PREDETERMINATION SETTLEMENT AGREEMENT

CP# 01-18-71443
HUD# 07-18-8305-8

Subject Property

City Square consists of one residential-unit building located at 210 E Walnut Street.² The residential building and common areas will be required to meet the same accessibility requirements of the ICRA and FHA. The residential building was issued a Certificate of Occupancy – signed by Cody Christensen, Building Official for the City of Des Moines, on March 31, 2017.

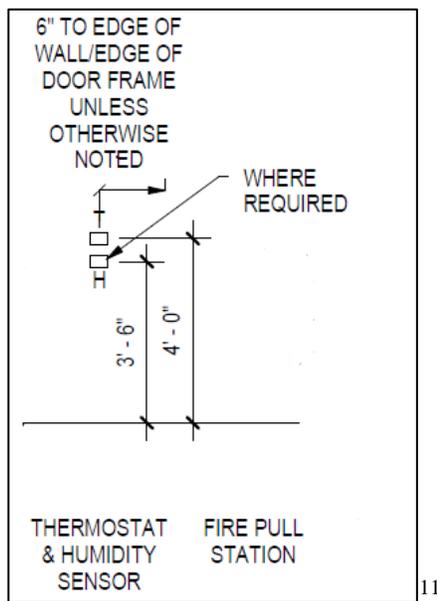
4) The table below lists the units with interior-threshold height values measured at the secondary doorway to the balcony that exceeded the ¼"-maximum allowed the Manual, and the measured heights.

Unit	Height
Unit 709	1 ⅜"
Unit 713 ⁹	1 25/32"
Unit 717	1 23/32"
Unit 723	1 23/32"

In the units listed in the table above, the interior threshold heights at the secondary doorways to the balcony significantly exceed the 1/4"-maximum allowed for thresholds without beveling. These thresholds are too high, rendering these thresholds unusable by persons using wheelchairs.

4) Respondents will make available to tenants an accessible ramp for one doorway leading from the living room to the balcony – if the interior finished floor surface is not carpeted – or, if carpeted, either shims under the carpet or an accessible ramp at the interior side of the thresholds of one doorway from the living room to the balconies at the units with interior thresholds that exceed the 1/4”-maximum height.

4) ICRC agrees with Respondents' proposal to make available to tenants accessible ramps or shims but will require these ramps or shims to be flush against the interior thresholds for access to all balcony doorways located in each unit which exceed the 1/4"-maximum height, and not only at the doorway from the living room to the balcony in each unit.²² Within 30 days of the date of the Closing Letter from ICRC, Respondents will advise current tenants that ramps or shims will be installed in their unit and provide tenants an opportunity to elect not to have such ramps or shims installed in their unit. Current tenants will be advised in the initial correspondence that if the tenant requires a ramp or shim in the future due to a disability such ramp or shim will be provided at no cost to the tenant. For new tenants, a pre-lease checklist will include the option for a tenant to elect not to have a ramp or shim installed in their unit to access all balcony doorways located in each unit, and indicate that this retrofit will be completed if they do not make a selection. In the absence of an election by the tenant not to have ramps or shims installed, Respondents shall install the ramps or shims.

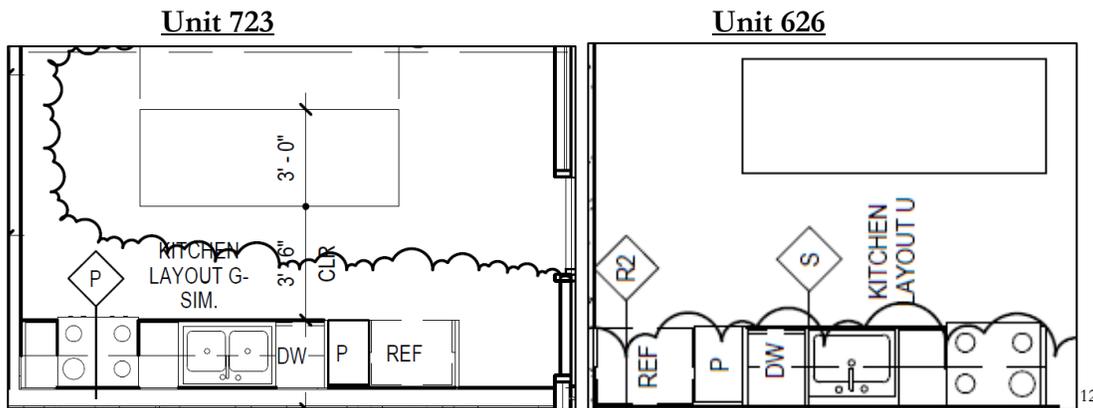
6) The kitchens in Units 103, 109, 414, 626, and 723 have an island. The width of the path between the island and the opposing features was measured at less than 40, as reported in the table at the top of the next page.

UNITS	MEASUREMENT TAKEN BETWEEN ISLAND AND ...	CLEAR OPENING WIDTH IN INCHES
Unit 103	Refrigerator	39 ¼
Unit 109	Refrigerator	39 ¼
Unit 414	Range	37
Unit 414	Opposing counter near refrigerator	39 ⅝
Unit 626	Range	39 ⅜
Unit 626	Refrigerator	34 ¼
Unit 723	Refrigerator	33 ¼

Respondents submitted plans for all units. The clear width of the path between the kitchen island and opposing features is the same for all units in the table above. The plans for the kitchens in Units 723 and 626 are shown below:

The kitchen island was designed to be (i) 48" away from the opposing features in Unit 626; and (ii) 42" in Units 103, 414, and 723.

The widths of the paths in these kitchens would have been compliant with the required 40"-minimum width if installed according to the plans. But as built, they are too narrow, rendering them unusable by persons using wheelchairs.¹³

6) Respondents will either relocate or otherwise retrofit the electrical plug for either the refrigerator or the range to allow the appliance to be moved further away from the opposing countertop so as to increase the clear width of the path around the kitchen island to no less than the 40” minimum.

6) ICRC agrees with Respondents' proposal to either relocate or otherwise retrofit the electrical plug for either the refrigerator or the range to allow the appliance to be moved further away from the opposing countertop at Units 103, 109, 414, 626, and 723 – as applicable – so as to increase the clear width of the path around the kitchen island to no less than the 40" minimum. ICRC will also require Respondents to verify compliance of the clear width of the path around the kitchen island in all units with similar floor plans as the aforementioned inspected units, as reported in the table on page 3 of the current agreement.

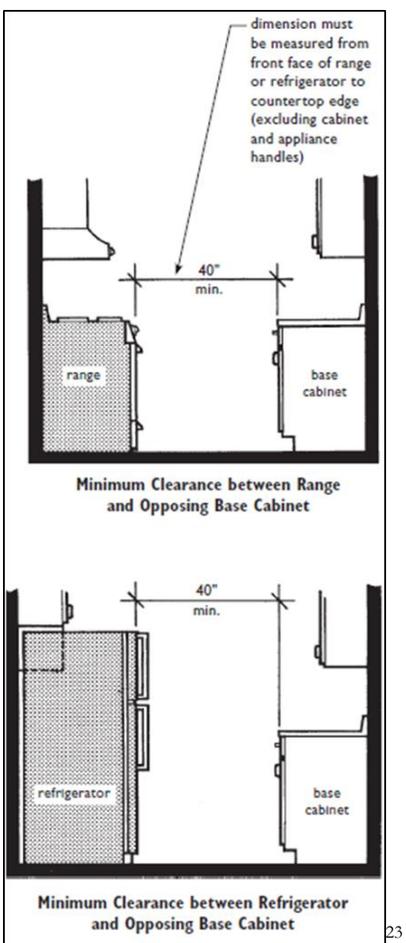
- (a) The parties agree the height to the top control buttons of the thermostats in Units 109, 417, 508, 626, 627, 709, 713, and 723 was measured at no less than 59", which exceeds the 48"-maximum height allowed by the Manual.

- (b) Respondents agree they will relocate the thermostats at the inspected units listed in (a) paragraph above – which are wireless and removable – to a default location that is accessible and reachable at a height that does not exceed the 48"-maximum allowed by the Manual, such as the kitchen cabinet drawer adjacent to the refrigerator.

(g) Respondents agree they will verify that the thermostat is at the accessible default location at the end of each tenancy, which may include replacing any missing thermostats and placing the thermostat at the accessible default location if left by the tenant at a different location within the unit.

(h) Respondents agree (i) to measure the height to the top controls of the thermostats at all the other similarly-units – which are included in Groups 1, 4, 5, 6, 7, 9, 10, and 11 that are described in the table on page 3 of the current agreement; and (ii) complete the same retrofit described in the paragraphs above – (d), (e), (f), and (g) – at all units with thermostats that exceed the 48” maximum height.
